AS BUILT PLANS

PELICAN CREEK
SALMON WAY, PELICAN ALASKA
GENERAL LAYOUT

BRIDGE NO. 1491
DWG. NO. 1

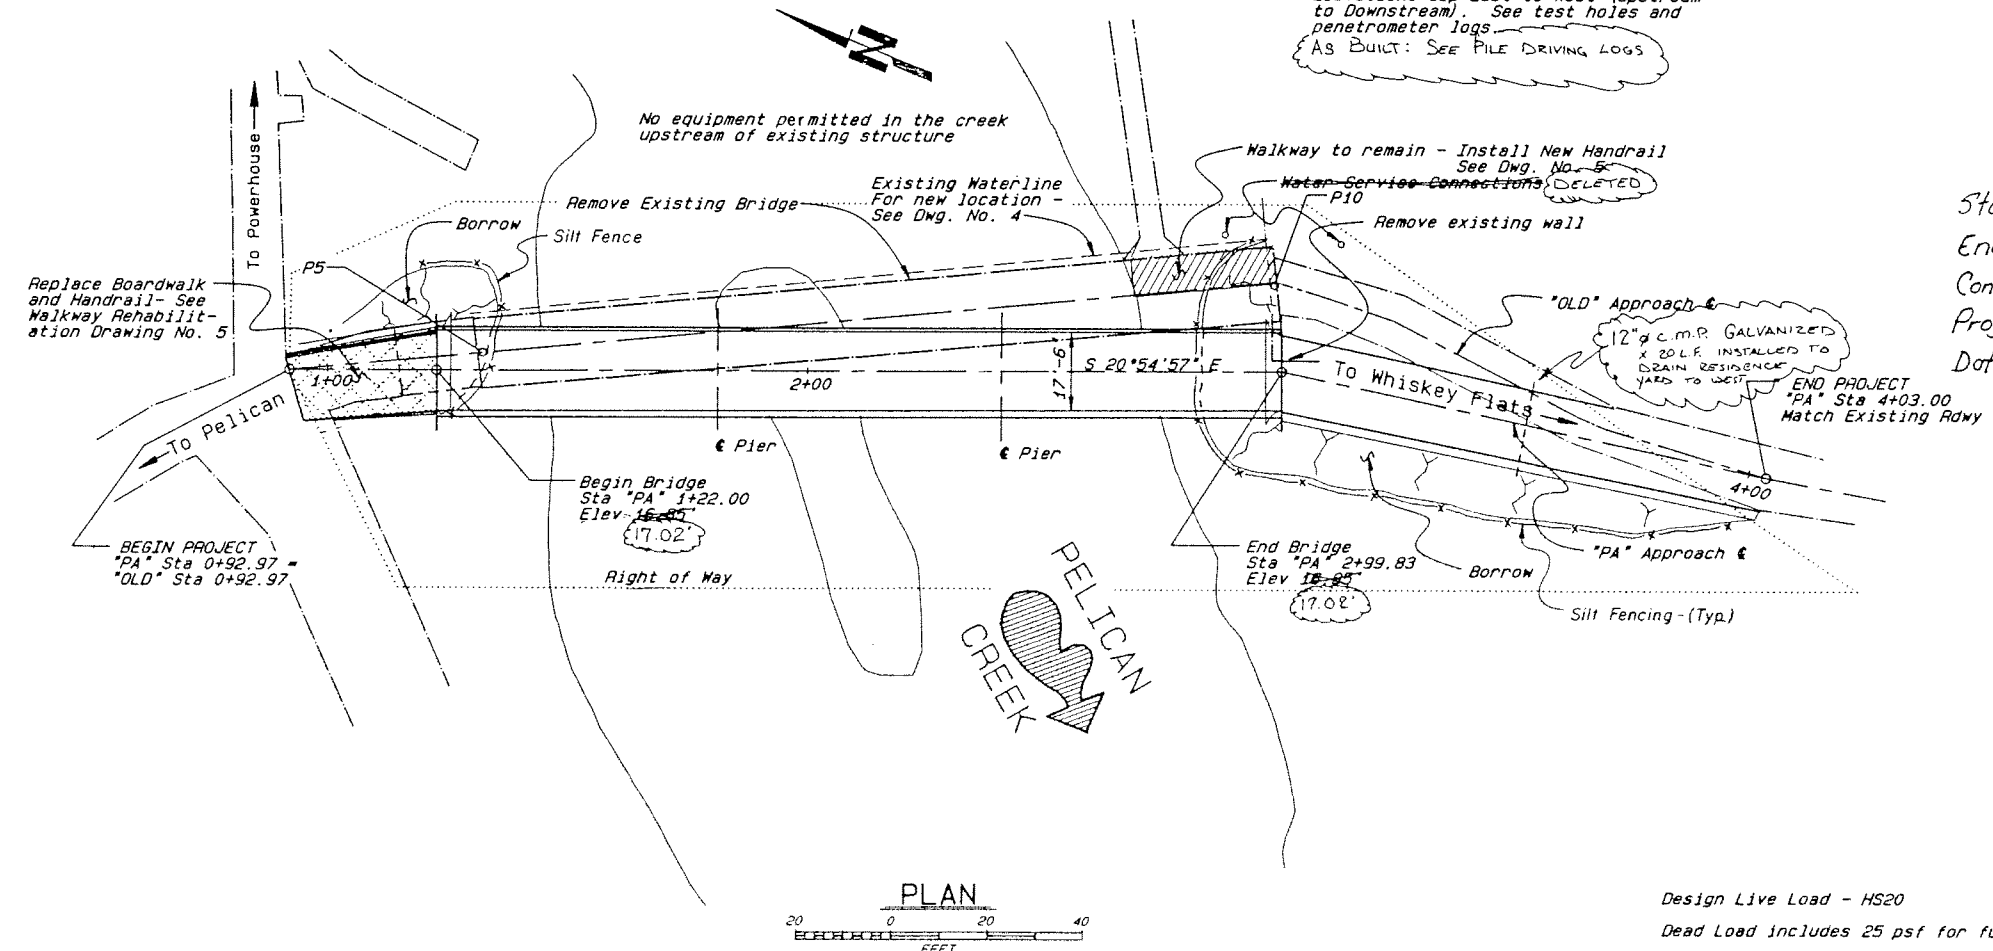
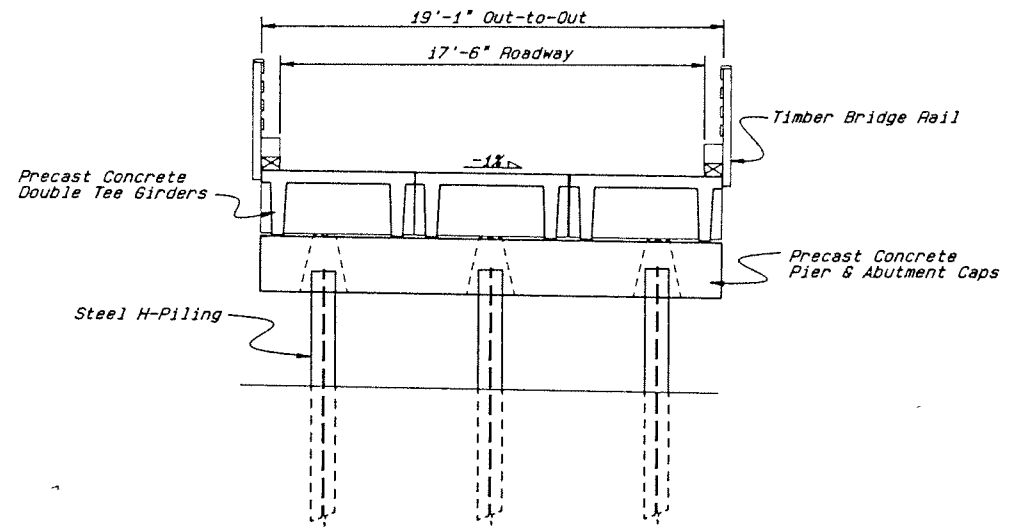
SUPPLIER INCREASES DOUBLE TEE DEPTH ON ENDS BY 2" - WASN'T DISCOVERED PRIOR TO PILE CUTOFF AND BRACKETS BEING WELDED ON PILES - ROAD AND WALKWAY ADJUSTED TO CHANGE

Bedrock profile is extremely variable. Elevations dip East to West (Upstream to Downstream). See test holes and penetrometer logs.
AS BUILT: SEE PILE DRIVING LOGS
